Minnetonka Beach Parks Livingston Strong Playground Task Force

Drainage Recap

To: City Council/Task Force From: Darren Amundsen
File: Half Moon Park Drainage Date: July 17, 2020

HALF MOON PARK

Colors

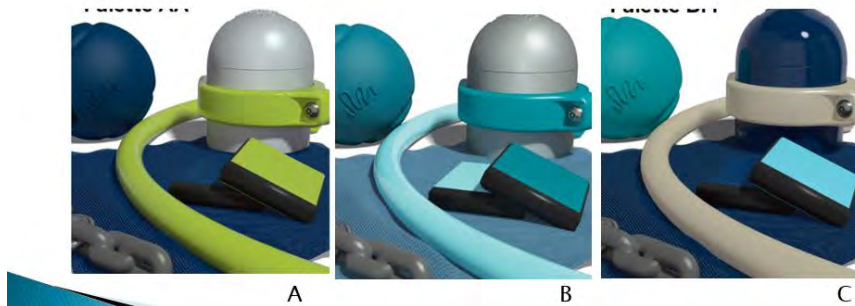
Team was presented with color pallet being reviewed by LST. Colors were presented as to blend in with the current signage in Minnetonka Beach.

Poured rubber was presented as black from LST.

- Prefer softer, neutral colors in B & C options – Teresa, Kim & Jodi
- Stay away from green in A (Teresa and Kim)
- Colors should blend in; Patty & Julia
- No objection to colors; Jodi and Lauren
